## ADDENDUM NO. 2

**PROJECT:** **MOORE COUNTY, NC**  
**Morrison Bridge Road Water Main Replacement**  
**Project Bid No: IFB 2021-05**

**DATE:** **December 14<sup>th</sup>, 2020**

D-6

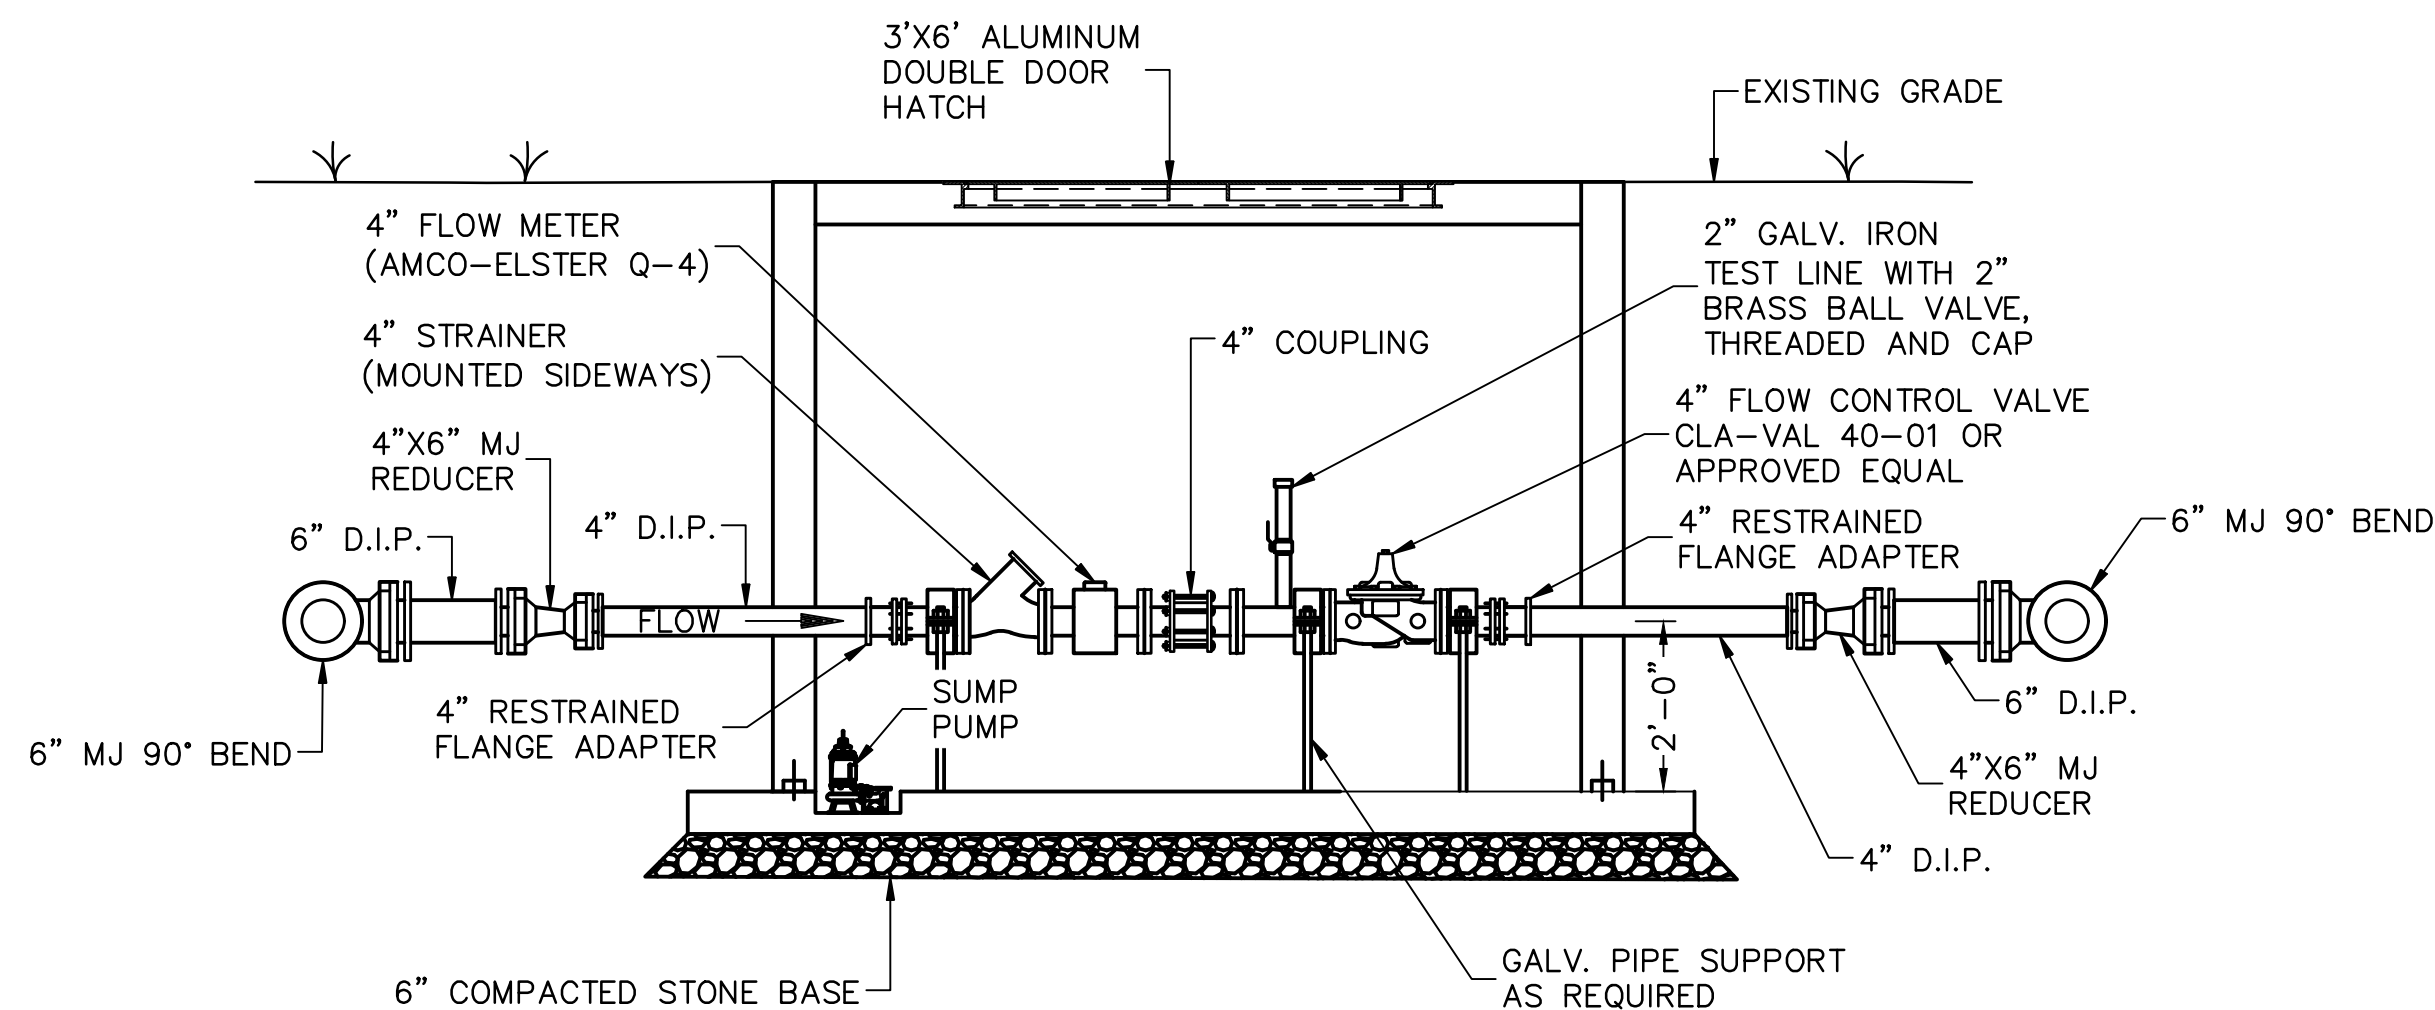
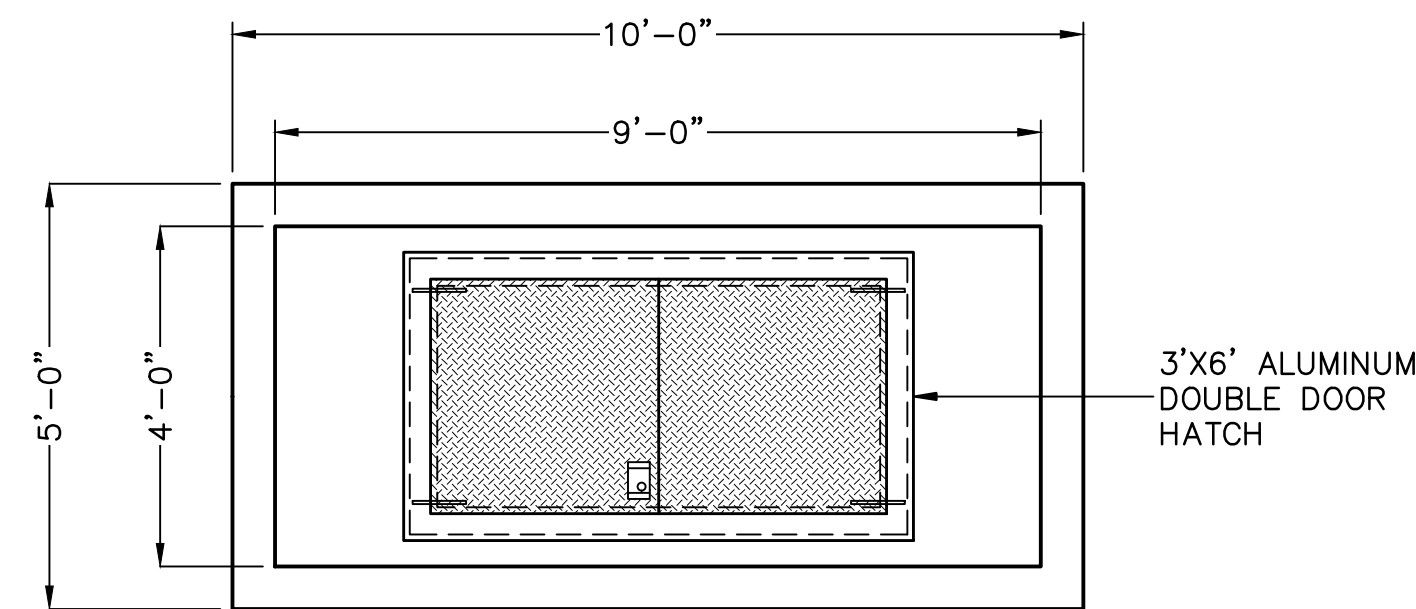
Enclosed is the revised plan sheet D-6. The flow control valve shall be CLA-VAL 40-01 or approved equal.

7. FLOW CONTROL VALVE SHALL BE CLA-VAL 40-01 OR APPROVED EQUAL.
8. METER SHALL HAVE HRW APPROVED RADIO READ CAPABILITIES.
